□  
**PRODUCT CHANGE NOTICE**  
PCN Form (D4-E000-73)

**PCN#11-007-1**

**MODEL(S) AFFECTED:**

ERA-3+ and derivatives  
ERA-3SM+ and derivatives

### RF PERFORMANCE CURVES

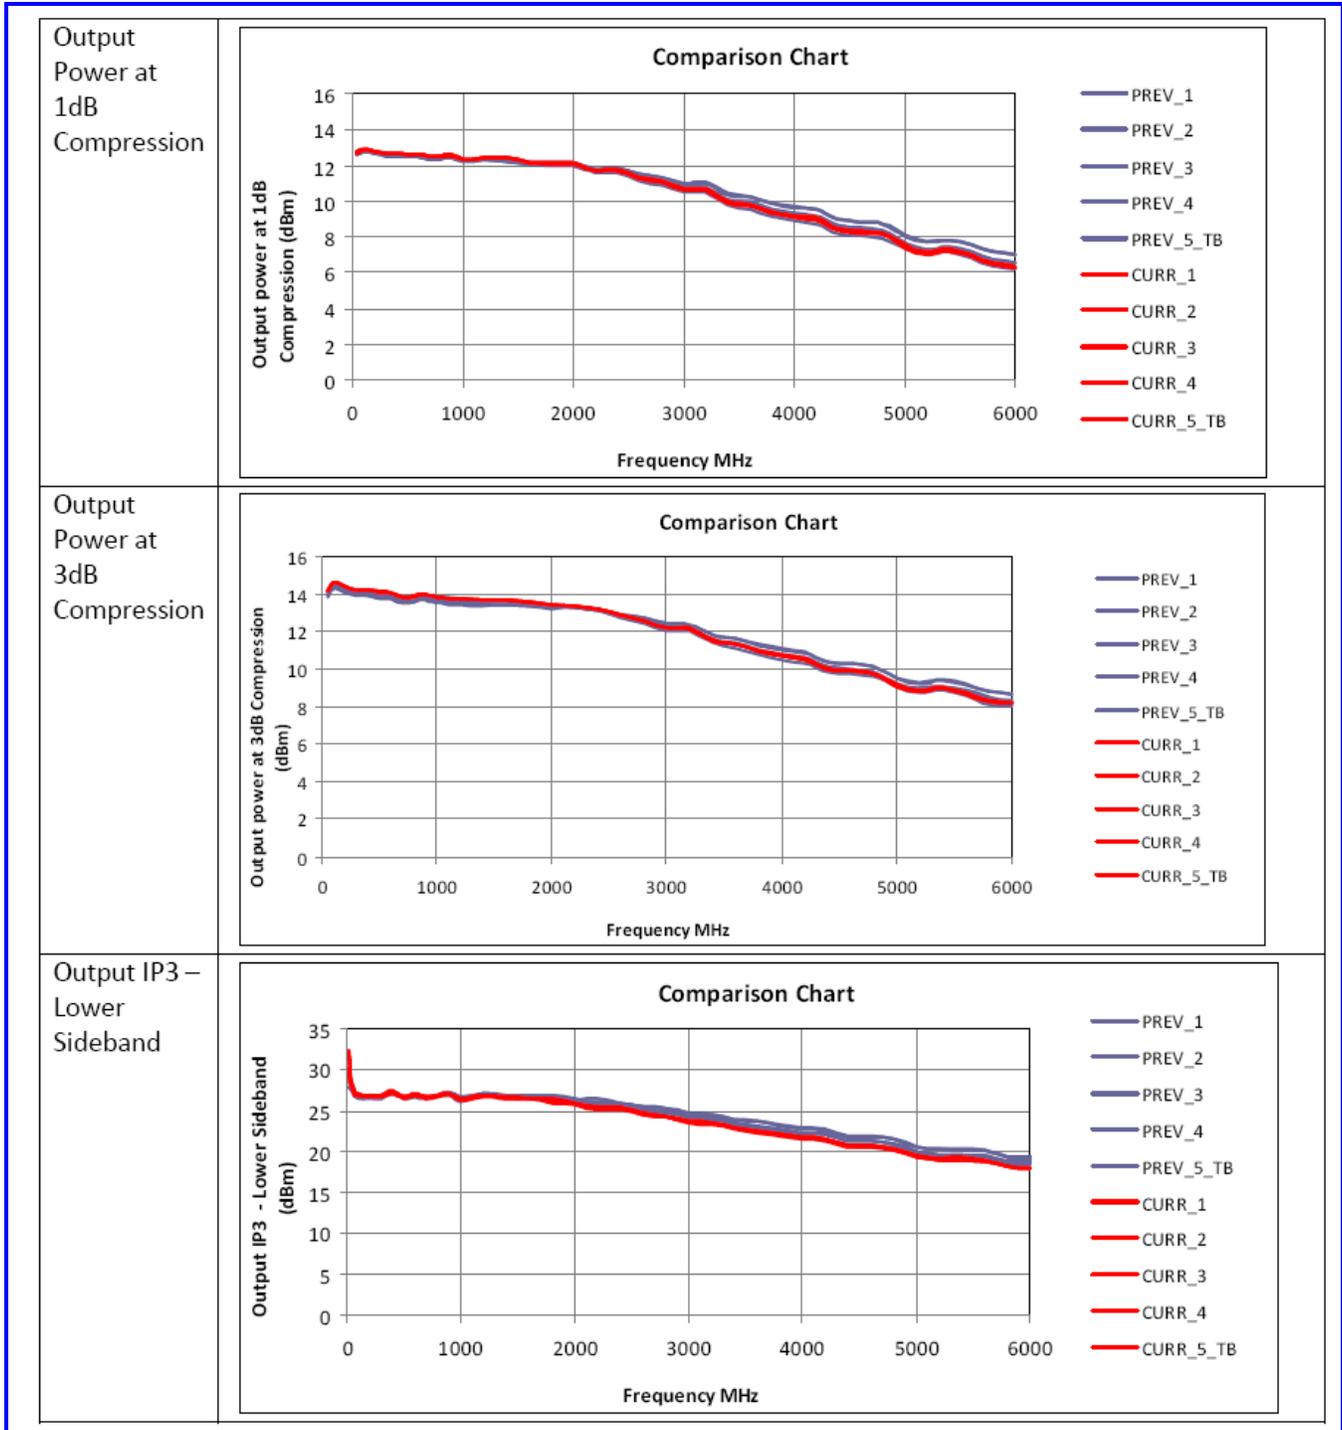
DATA SUPPLIED: Comparison Curves: S Parameters  
FOR ERA-3SM+ Output Power at 1dB and 3 dB Compression  
(ERA-3+ is straight lead Output IP3  
Version of ERA-3SM+) Noise Figure  
Device Voltage at Operating Current

**Note:** Unit #5 of previous and current version is mounted on test board (\_TB) and others mounted in test fixture during testing.

Output IP3 –  
Upper  
Sideband

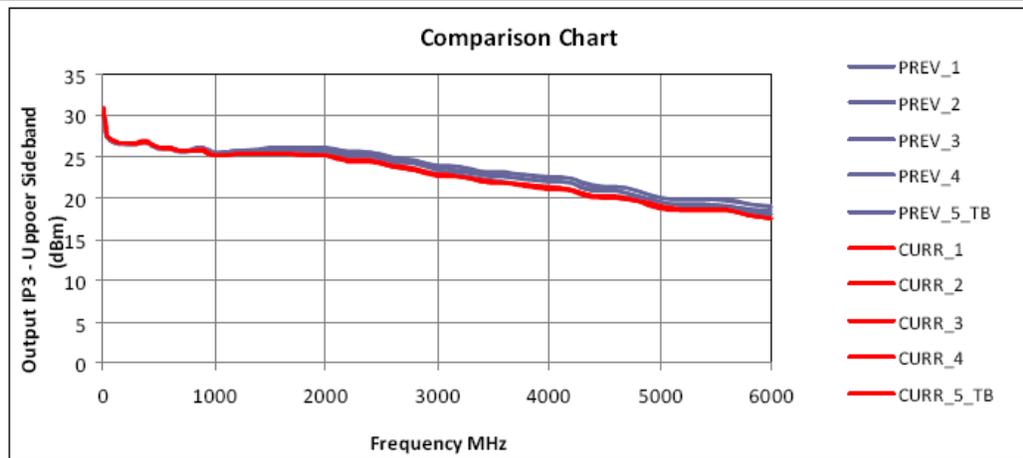
Current version of the ERA-3SM+ exhibits comparable performance of the previous fabricated version with the exception of gain at low frequency is higher by about 0.9 dB at 50 MHz

Noise Figure

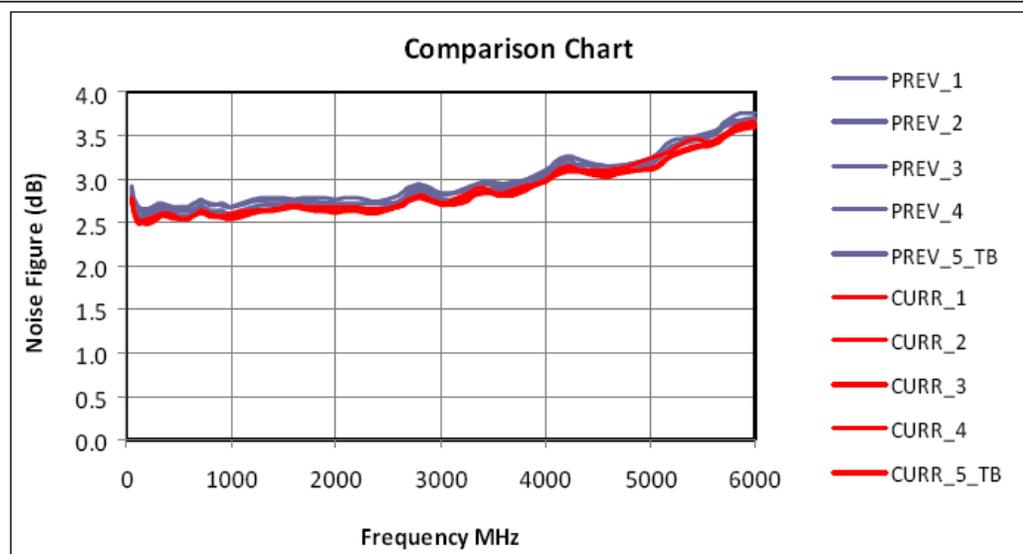
MHz	NF			DEVICE VOLTAGE at 35 mA		
	PREV	CURR	DELTA	PREV	CURR	DELTA
50	2.9	2.8	-0.1	3.27	3.26	-0.01
100	2.6	2.5	-0.1			
500	2.6	2.5	-0.1			
1000	2.6	2.6	-0.1			
1600	2.7	2.7	-0.1			
2000	2.7	2.6	-0.1			
2600	2.7	2.7	-0.1			
3000	2.8	2.7	-0.1			
4000	3.1	3.0	-0.1			
4600	3.1	3.1	-0.1			
5000	3.2	3.1	-0.1			
5600	3.5	3.4	-0.1			
6000	3.7	3.6	-0.1
